**WHEELING PLAN COMMISSION
THURSDAY, NOVEMBER 2, 2017 6:30 P.M.**

REQUEST FOR PLAN COMMISSION ACTION
STAFF PROJECT REVIEW

RE: **Docket Nos. 2017-15 & PC 17-18**
Uptown 500 (formerly Uptown 501)
500 W. Dundee Road (formerly 500 W. Dundee Road)
(2017-15) Final Planned Unit Development Approval of a
Mixed-Use Retail and Residential Development
(PC 17-18) Approval of a Preliminary Plat of Subdivision
(SCBA 17-43) Appearance Approval of Freestanding Signs

DATE OF REPORT: October 30, 2017

Mechanical Equipment Screening Exhibit

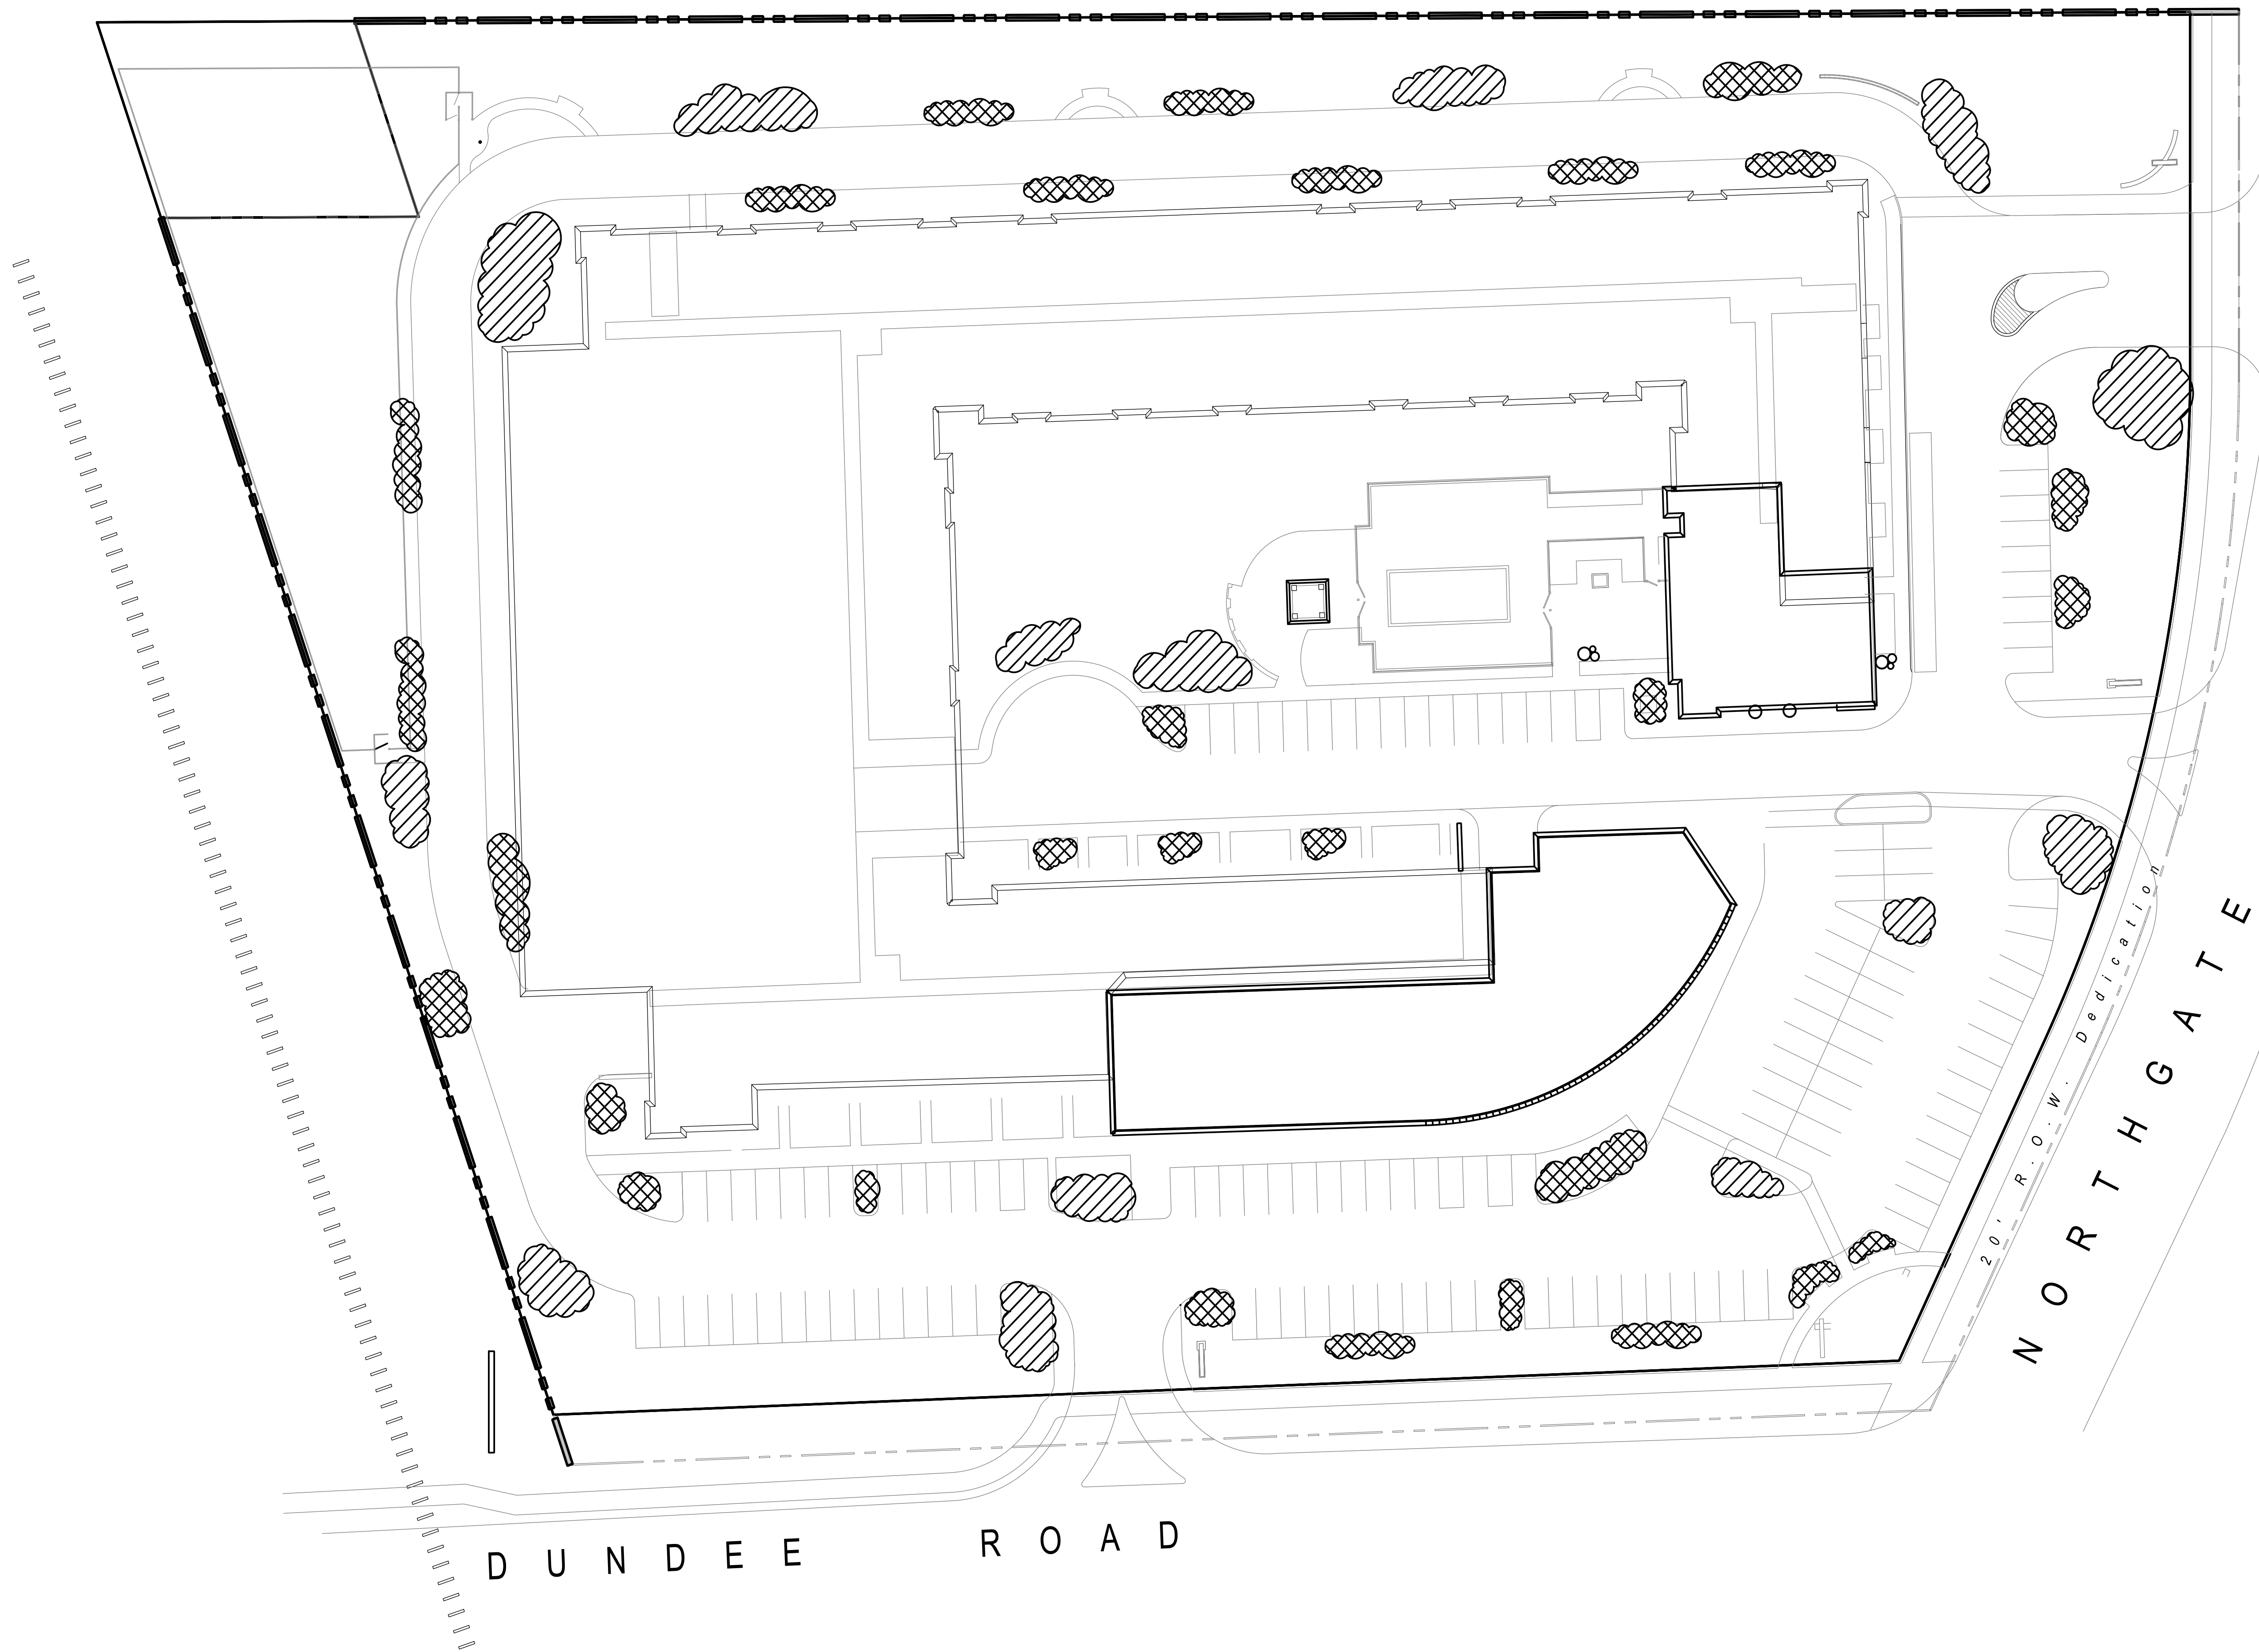
Screening: The screening of the rooftop units is shown on the Mechanical Screening Exhibit. The west elevation, which is the open side of the parking deck facing the railroad tracks, includes a planter system to partially screen the vehicles and improve the overall appearance of the garage.
